CITY OF WEST LAKE HILLS, TEXAS
NOTICE OF BOARD OF ADJUSTMENT (BOA) REGULAR MEETING
Wednesday, October 8, 2025 at 7:00 PM

3. Administration Discuss and consider action on approval of the September 10, 2025 Regular Meeting Minutes.
4. Land Use 217 Reveille Road - Discuss and consider action on recommendations from ZAPCO on proposed variances:

5. **Land Use 207 Yaupon Valley Road** - Discuss and consider action on a recommendation from ZAPCO on variances:

6. **Land Use 1206 Yaupon Valley Road** - Discuss and consider action on a recommendation from ZAPCO on variances:

Cut at Southwest Corner
p. 8

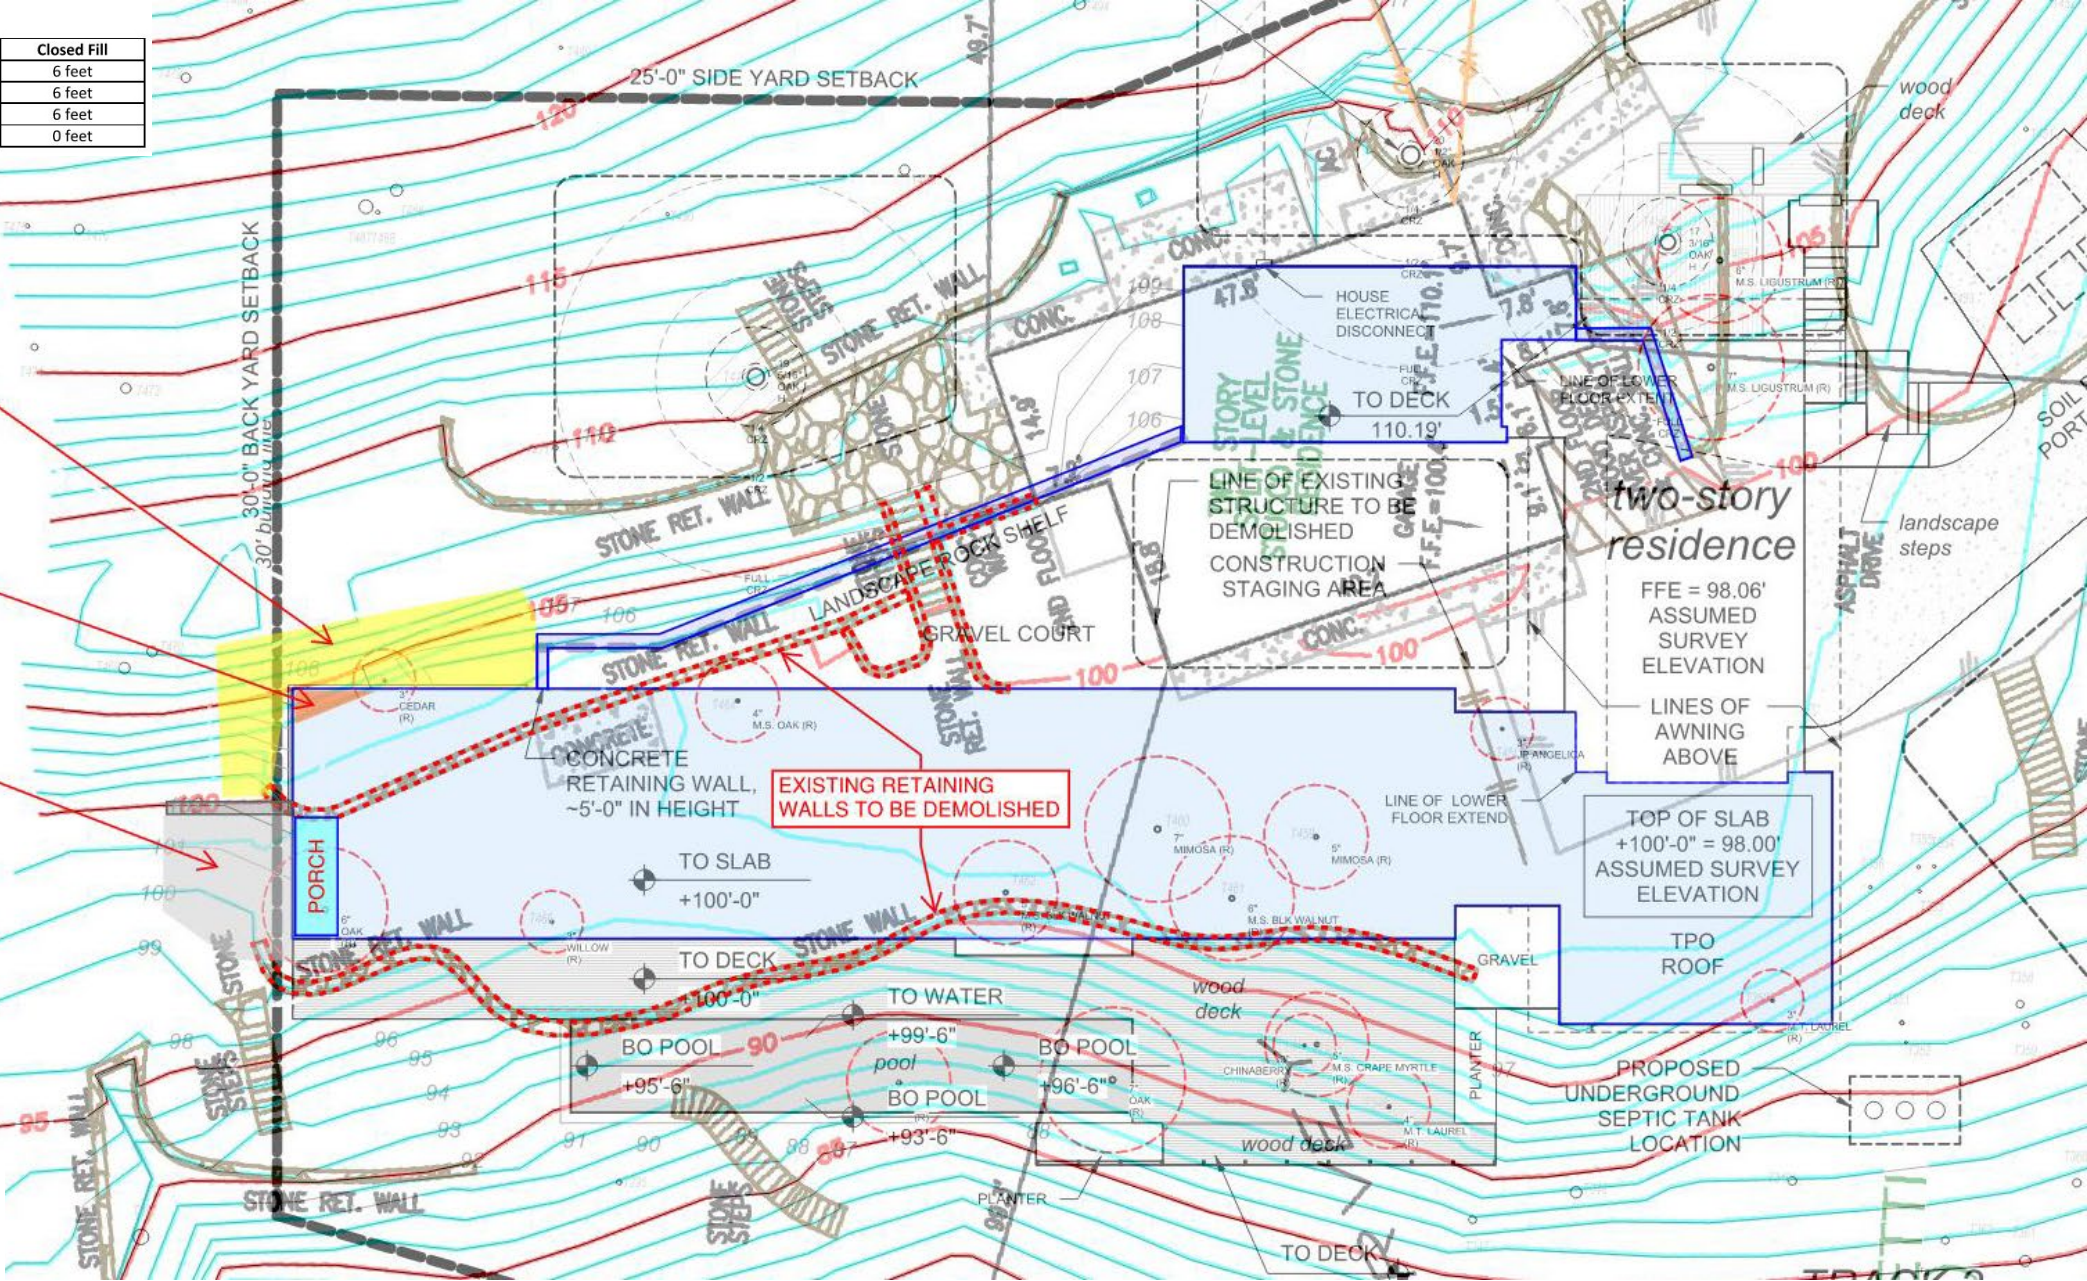
EXISTING SLOPE IN THIS AREA EXCEEDS 35%. GRADE TO BE MODIFIED TO ACCOMMODATE CONSTRUCTION OF RETAINING WALL AND DRAINAGE SWALE.

Fill at Garage
 p.9

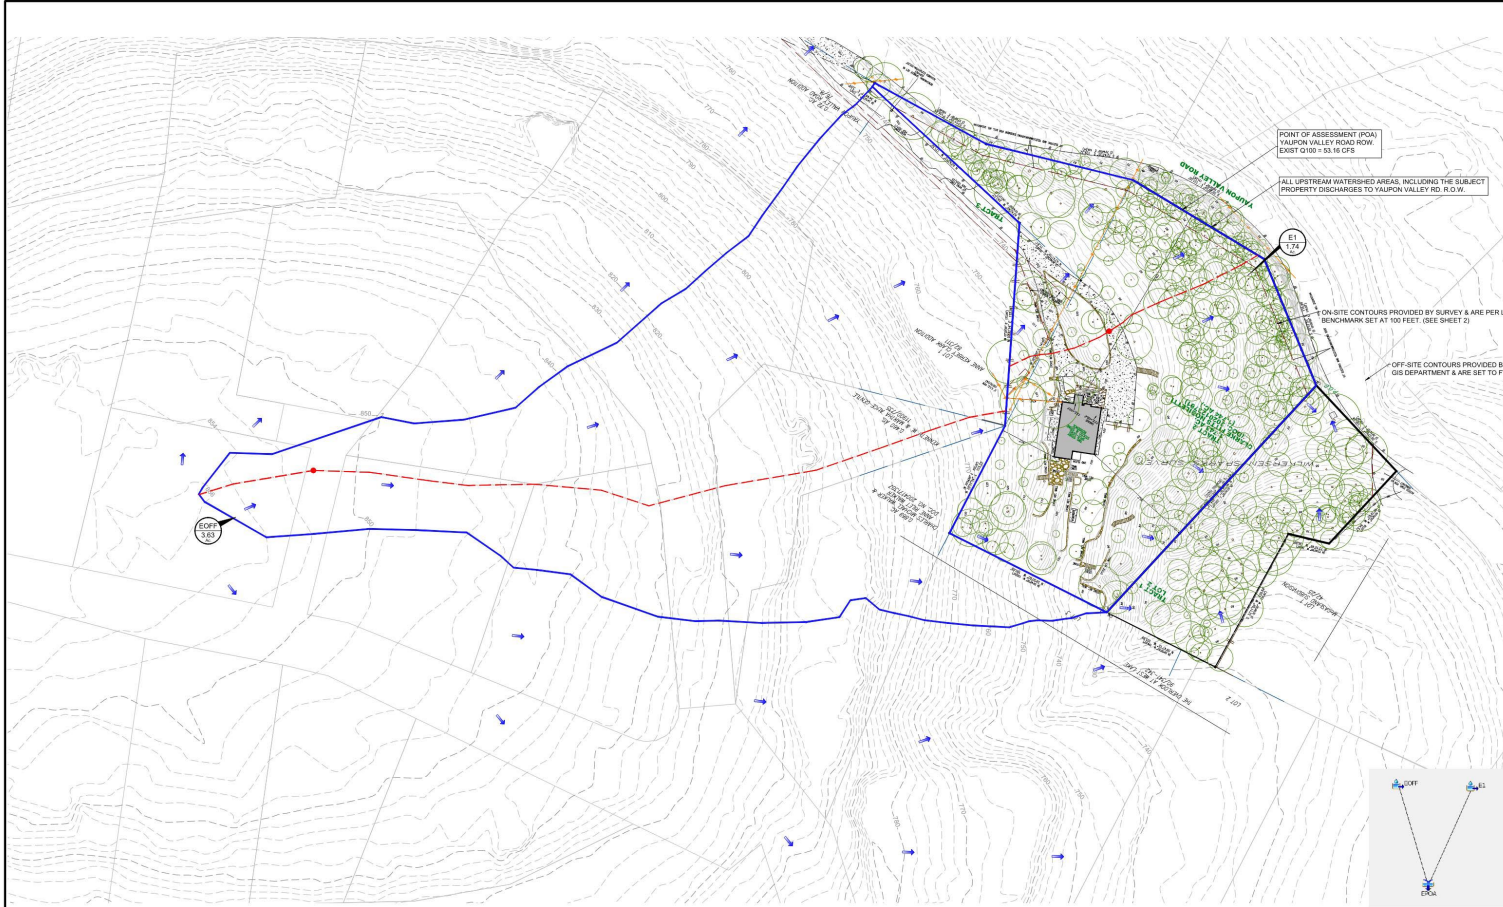
HIGH POINT OF GARAGE SLAB: 100'-6" (98'-6")
 GRADE AT BUILDING CORNER: 94'-3" (92'-3")
 DIFFERENCE: 6'-3" (CLOSED FILL)

EXISTING SLOPE IN THIS AREA EXCEEDS 35%. GARAGE SLAB TO BE CONSTRUCTED AS SLAB ON GRADE OVER CLOSED FILL CONTAINED WITHIN FOUNDATION WALL.

Request

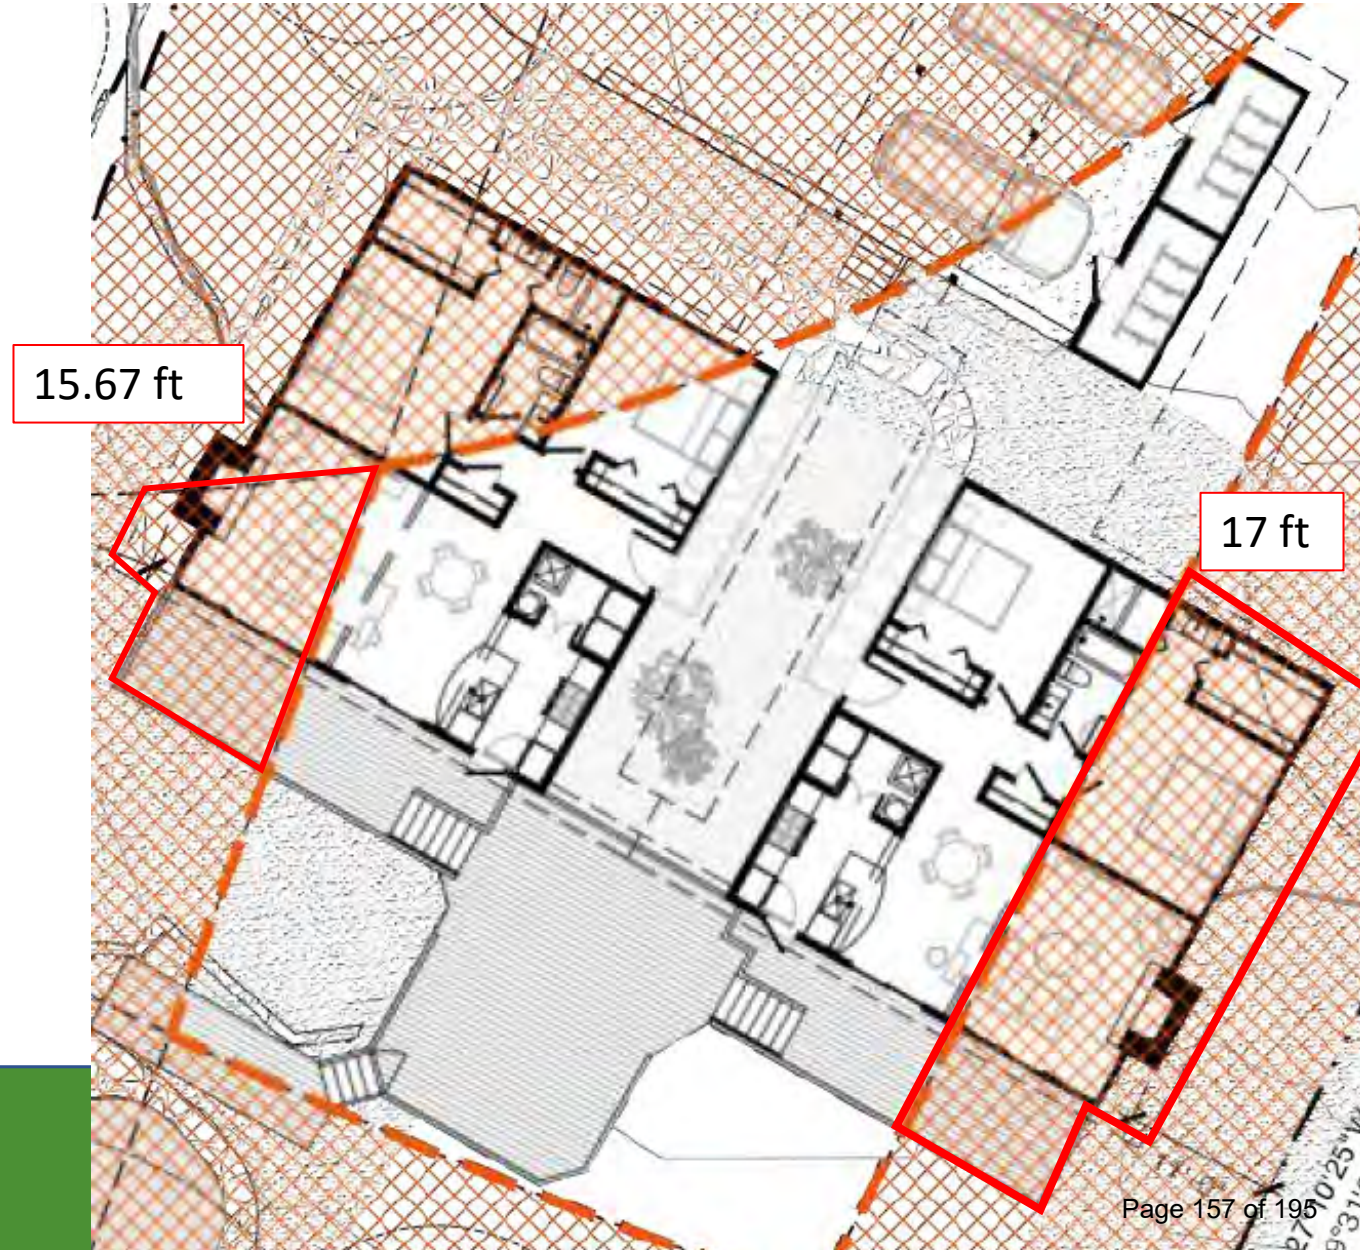
- The applicant is requesting to keep the existing encroachments into the 25-foot side setbacks.
